# Adding 220V power to the CMS bunkers - ECR

Sorina Popescu, Kansas University

## Requirements from EN-HE point of view:

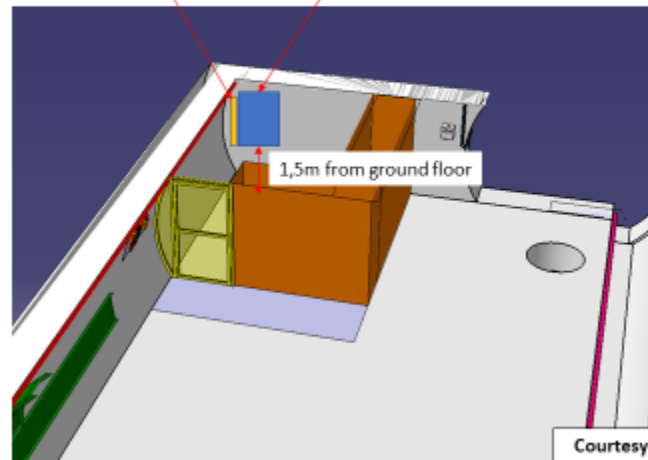
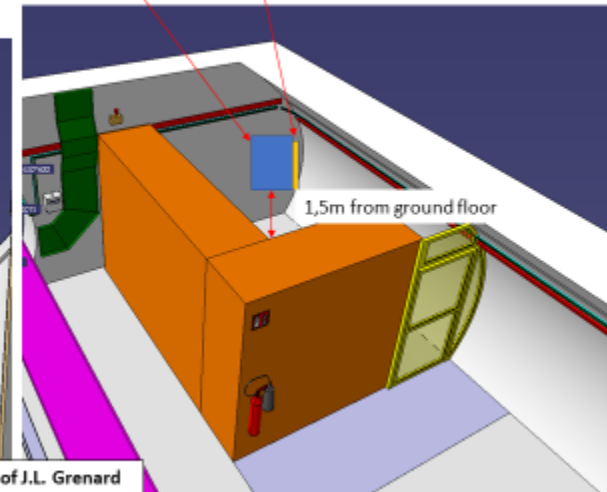
- To place the half-rack on the floor cannot be considered as an option, since a minimum of 2 sarcophagui (max 4) are foreseen to be stored inside the bunkers.

## Requirements from EN-HE point of view:

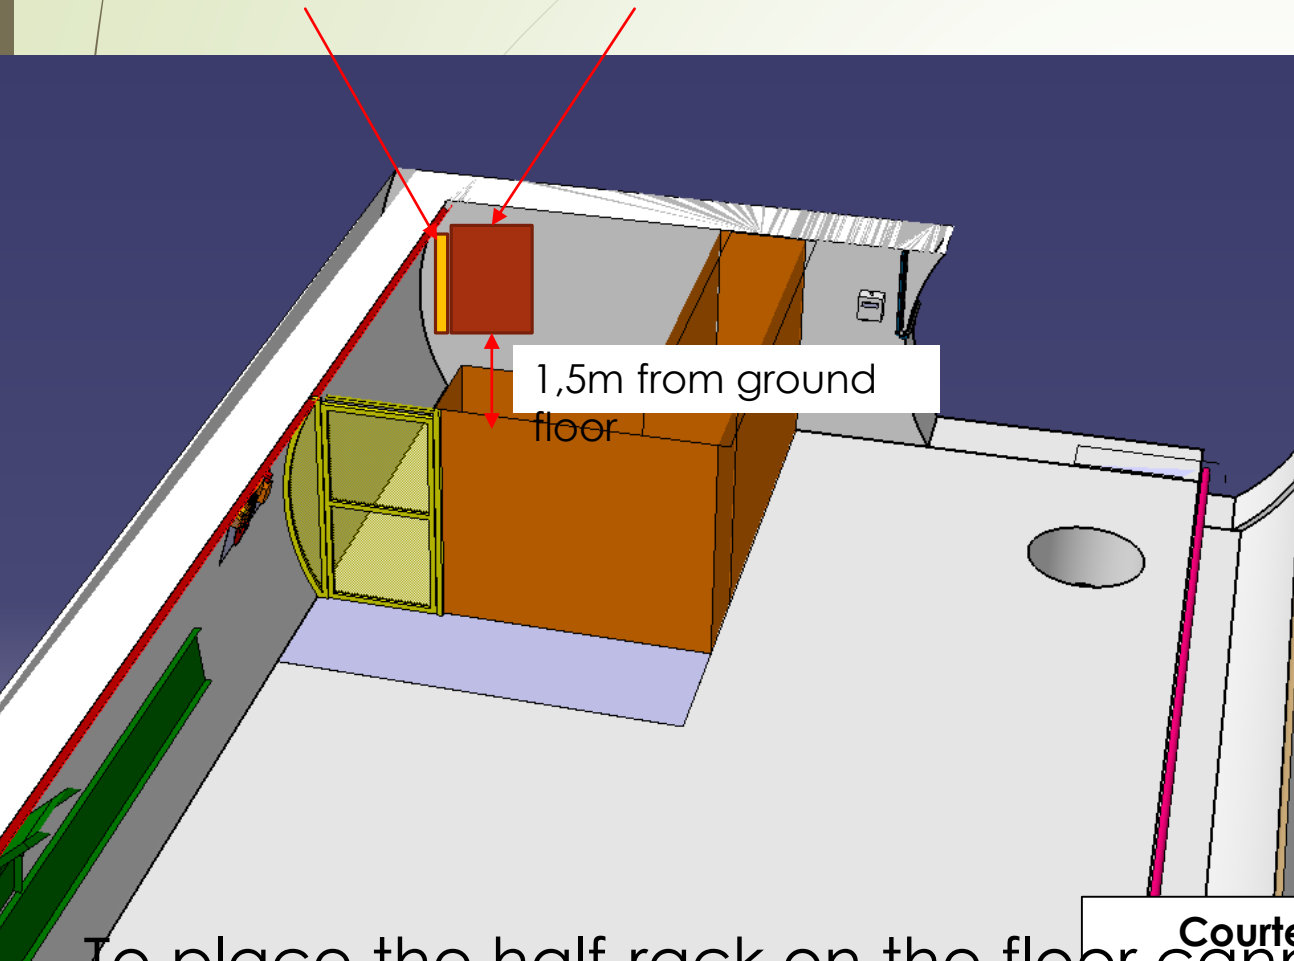
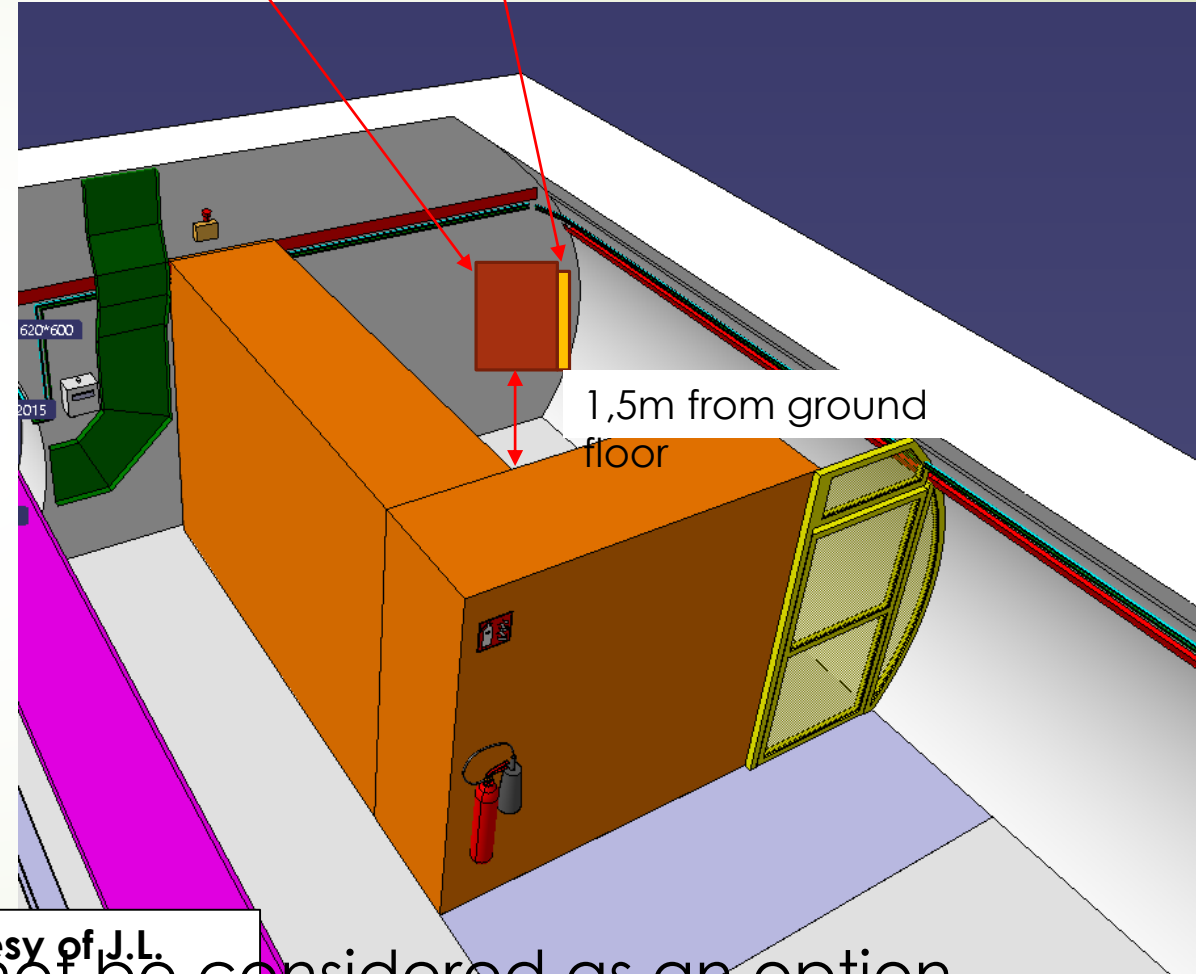
- To place the half-rack on the floor cannot be considered as an option, since a minimum of 2 sarcophagui (max 4) are foreseen to be stored inside the bunkers.

## 1/2 rack characteristics (installation LS3):

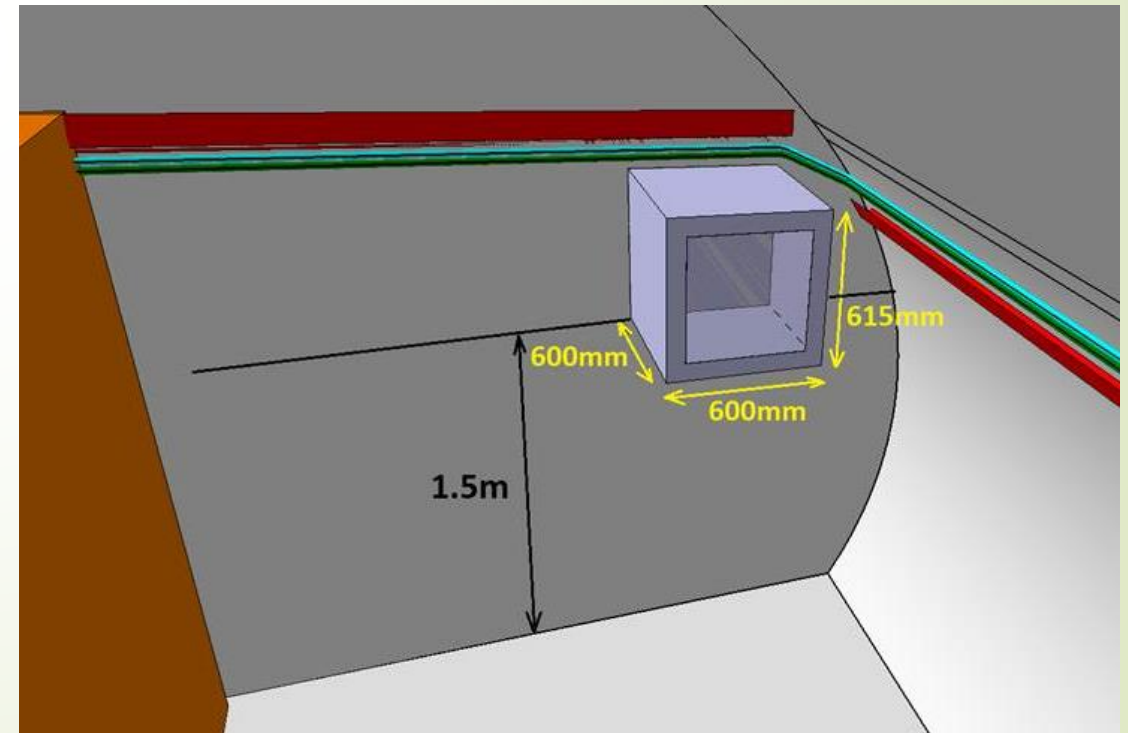
- To be placed 1.5m above the floor.
- It would be preferable to have the rack in the most radiation quiet part of the bunker, perhaps the corner, near the wall.
- Dimensions considered so far: *600x600x615mm* volume reservation.
- There is a CAEN HV main frame and then individual cards that produce the HV.
- The front end electronics is in a standard VME crate with a small patch panel above it to allow for strain relief of the cables.
- The rack can be air cooled with fan.
- Supporting solution to attach the rack on the wall will need to be found.

# Full integration proposal (UJ57):

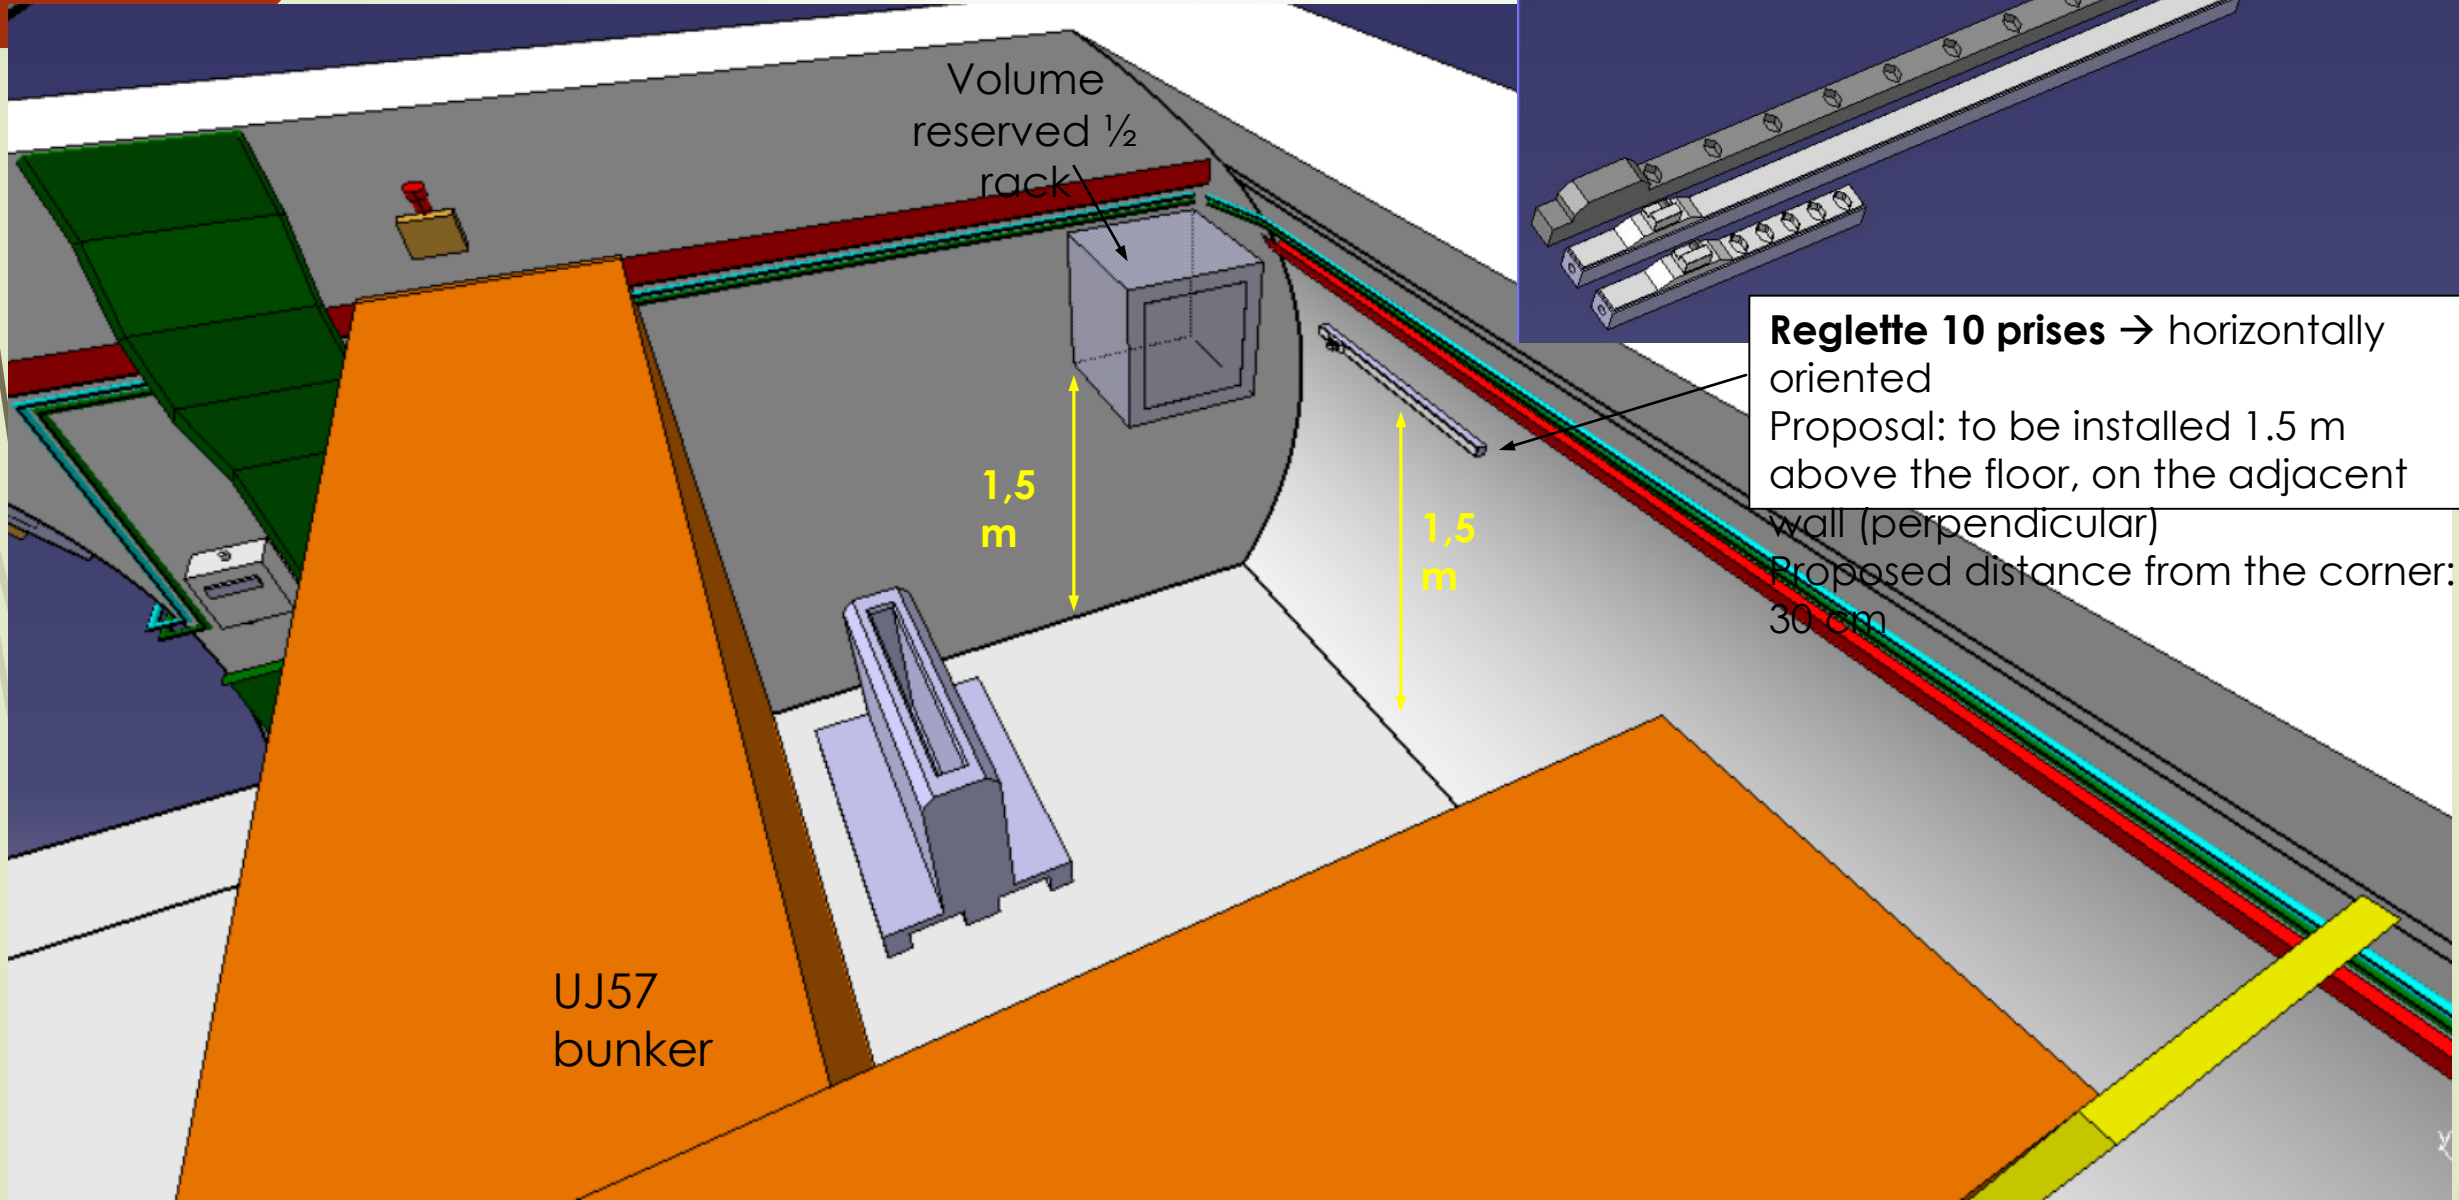
**Reglette 10 prises** → horizontally oriented  
Proposal: to be installed 1.5 m above the floor, on the adjacent wall (perpendicular)  
Proposed distance from the corner: 30 cm

# Full integration proposal (UJ57):

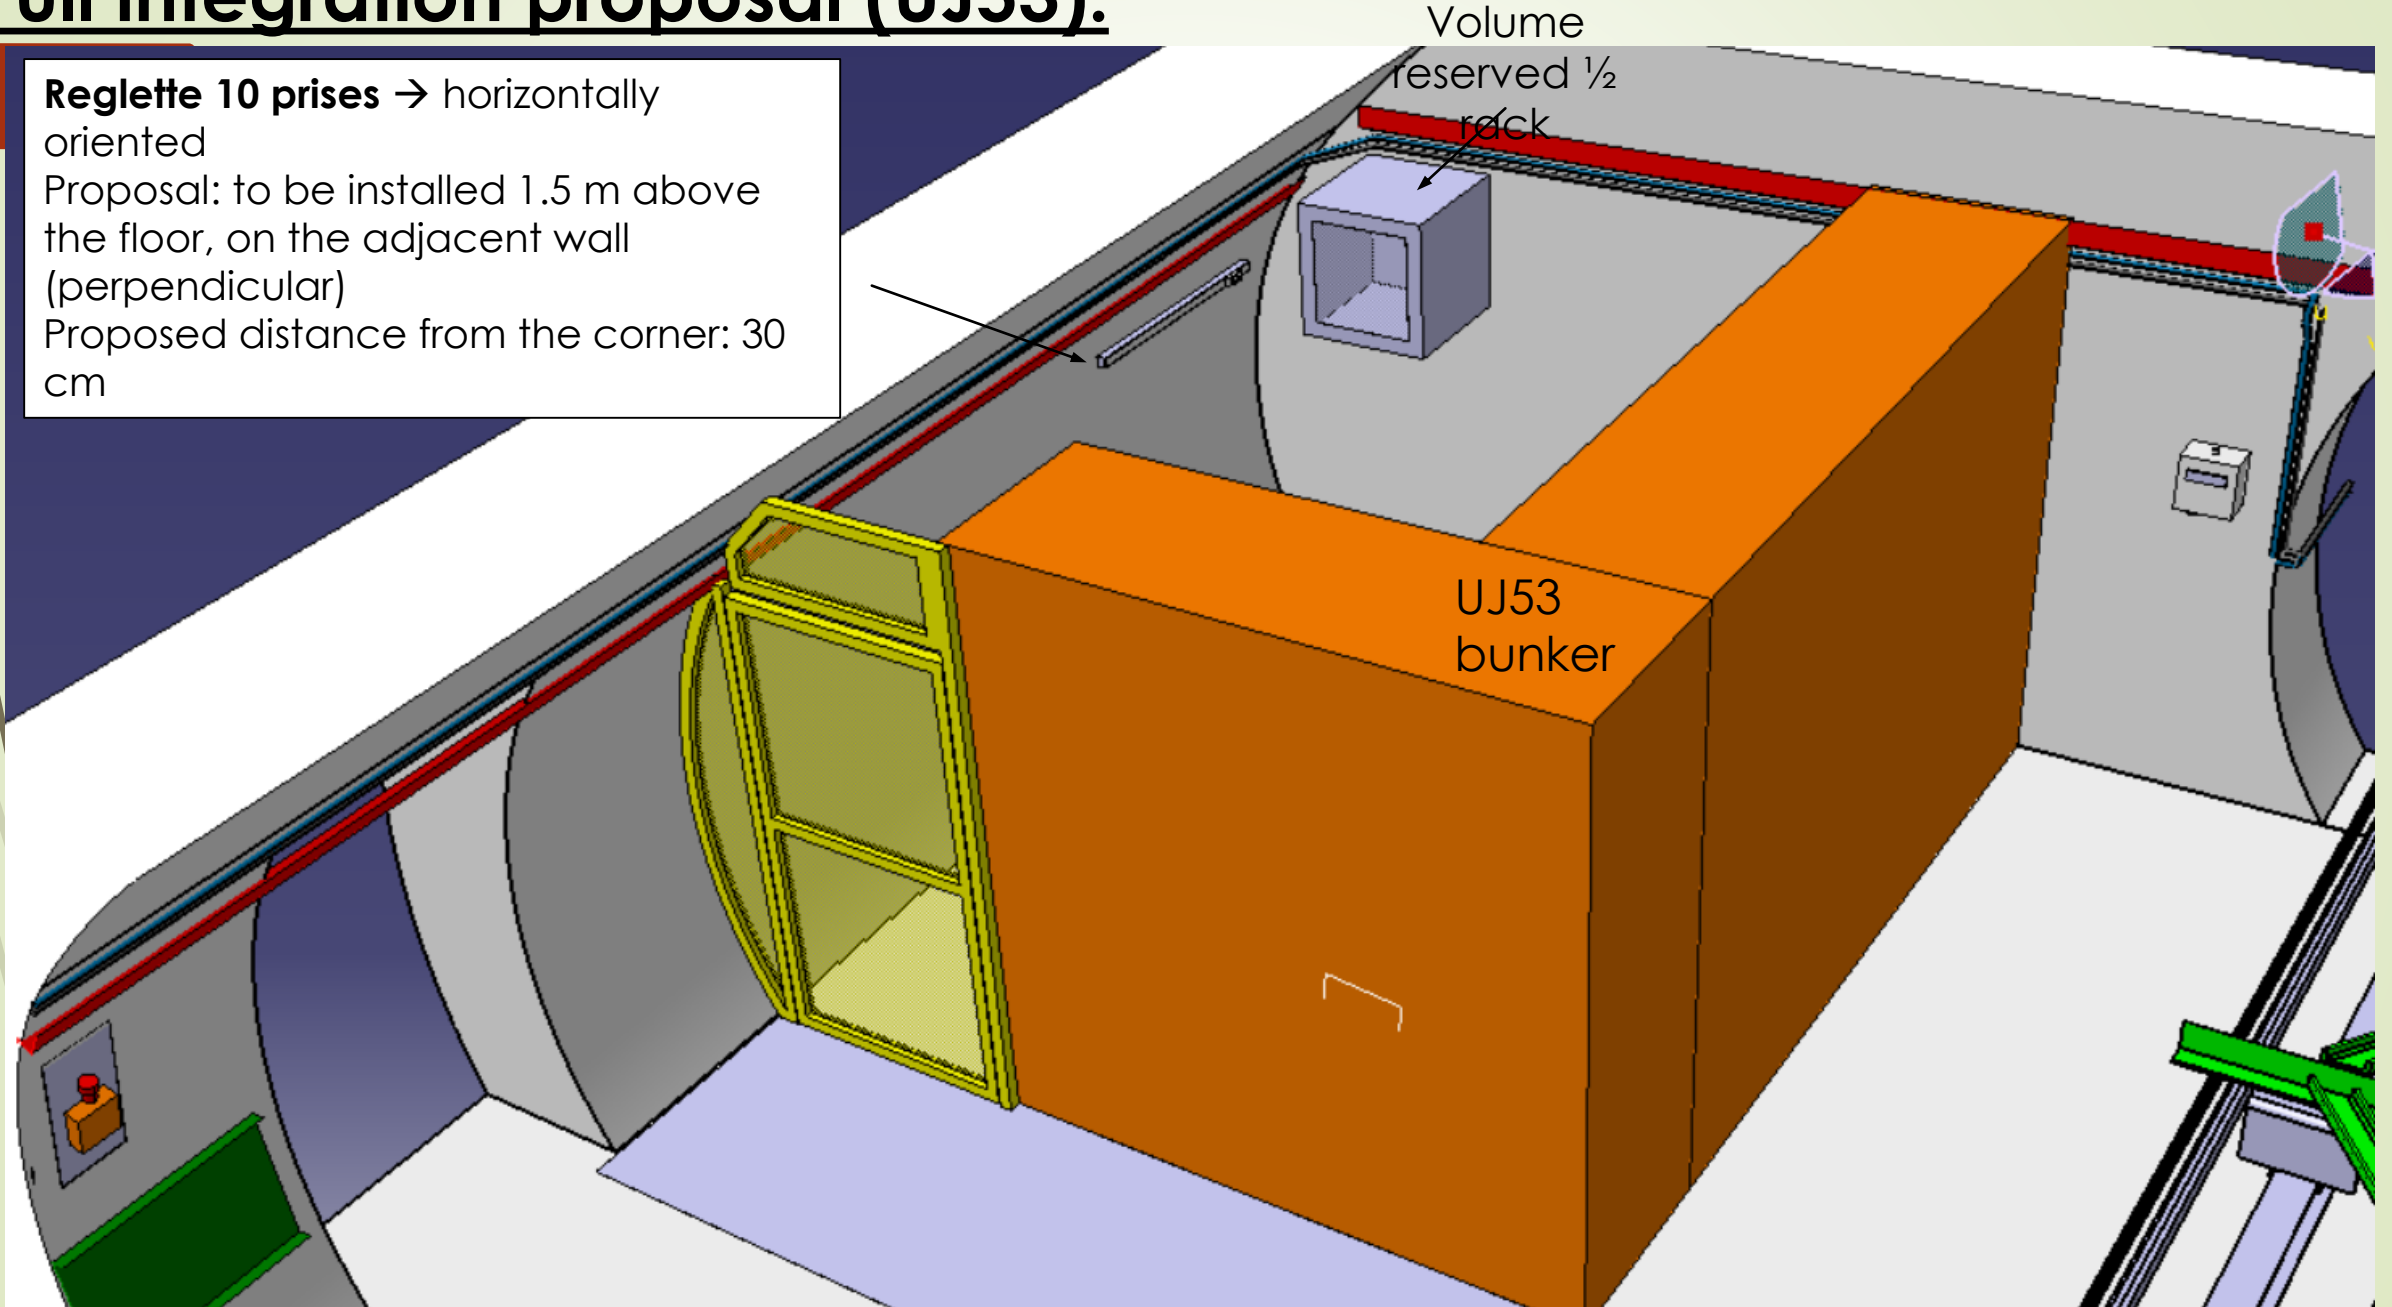
**Reglette 10 prises** → horizontally oriented  
Proposal: to be installed 1.5 m above the floor, on the adjacent wall (perpendicular)

Proposed distance from the corner: 30 cm
